REMARKS

LIQUID CRYSTAL DISPLAY... 07/19/04
Hidefumi Yoshida - 2803.66230
Greer, Burns & Crain, Ltd. (Patrick G. Burns)
ANNOTATED SHEET (312) 360-0080

Fig.49A

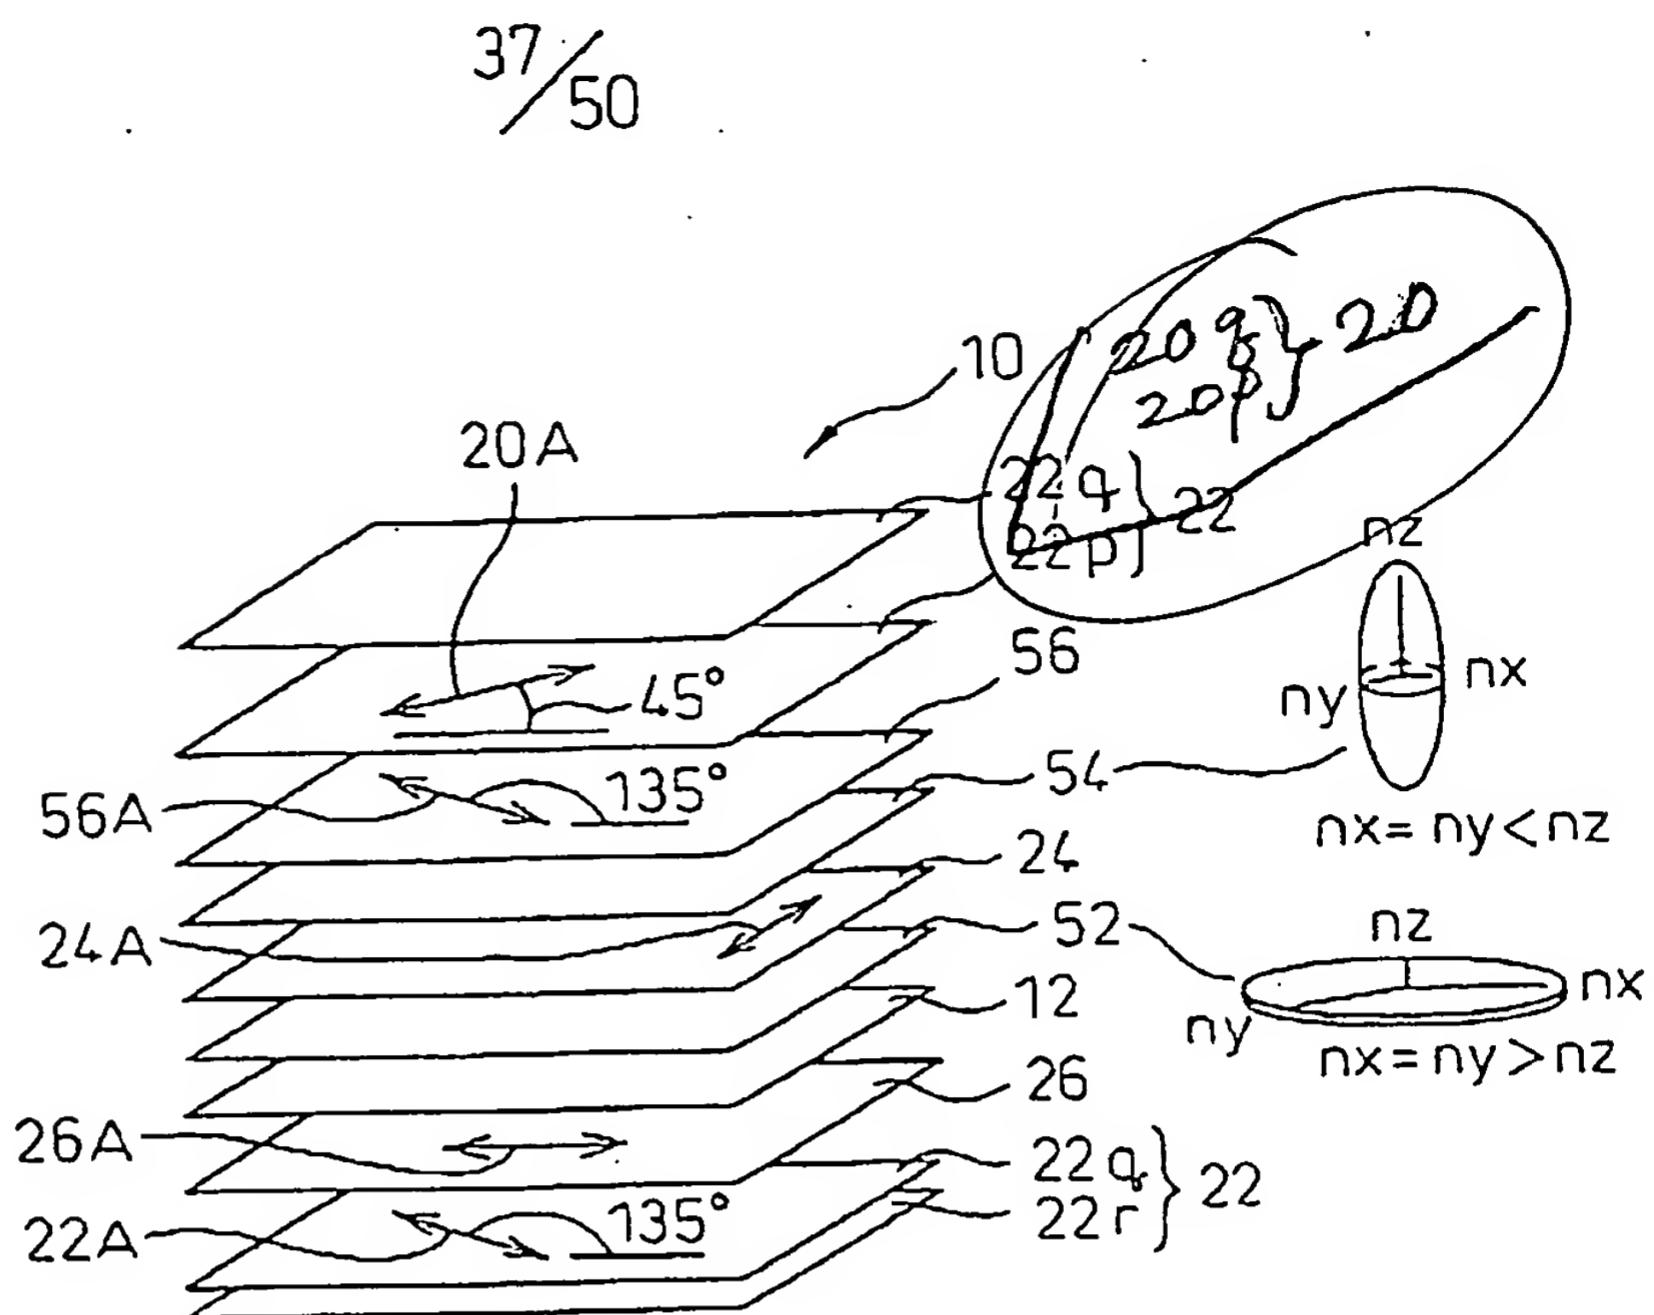
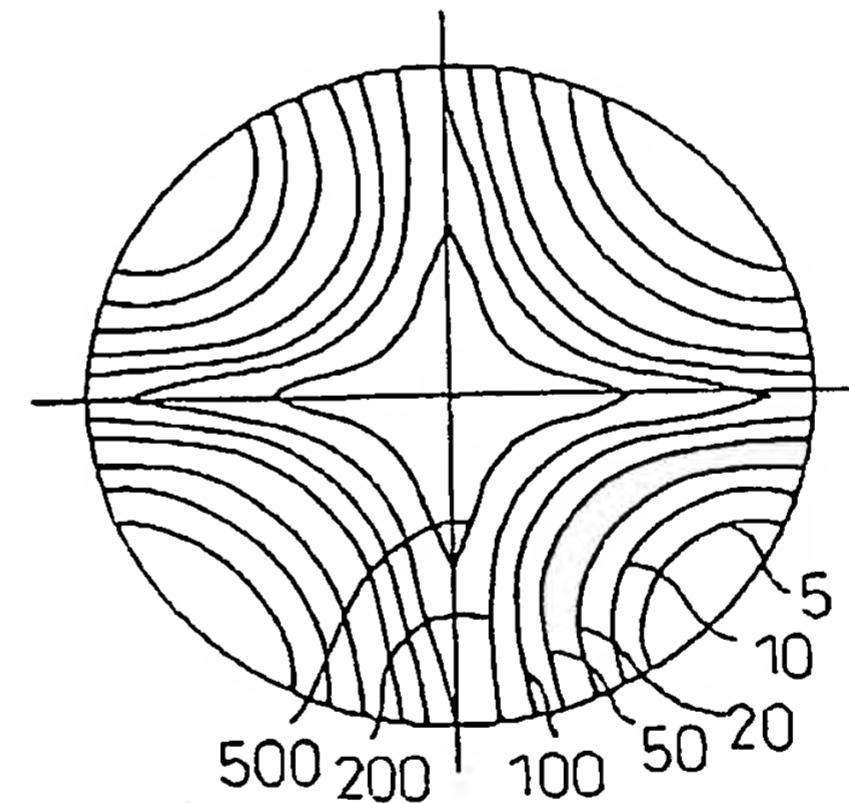
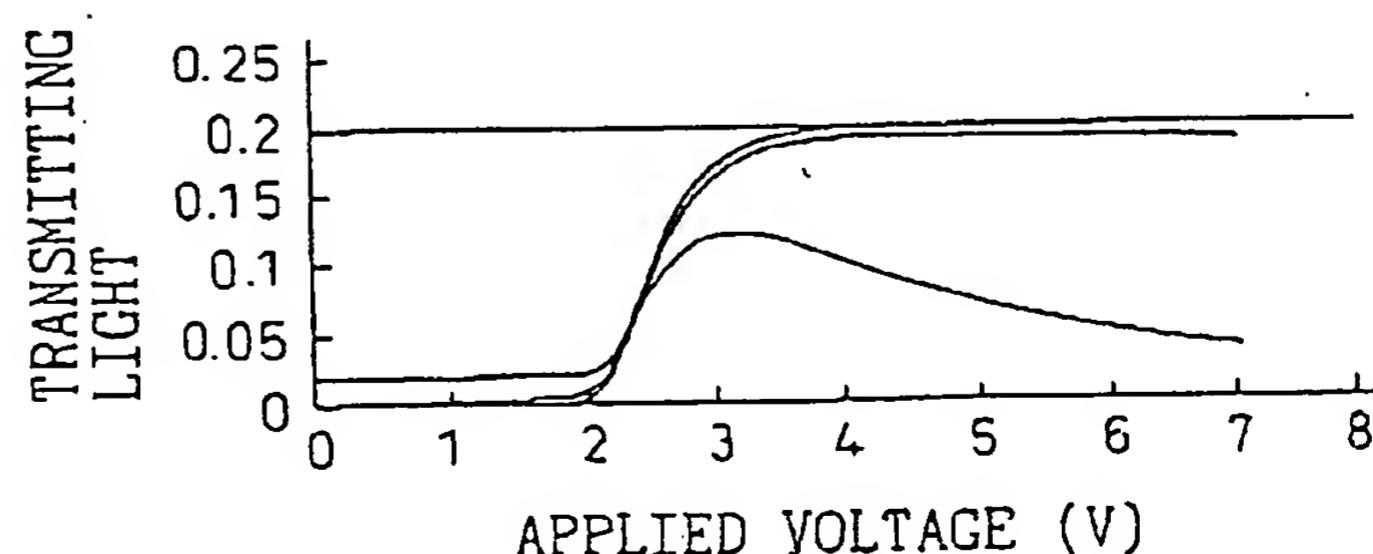
Figs. 49 and 53 have been amended to correct inadvertent typographical errors, without adding new matter. Approval is requested.

Claims 14-16 have been added, and are based on the embodiment of Fig. 53. The features of the first to third optical plates are explained with respect to Fig. 49. The first and third optical plates correspond to films 52, 54 and 56. The film 56 fundamentally shows the refractive indices as recited in claim 14.
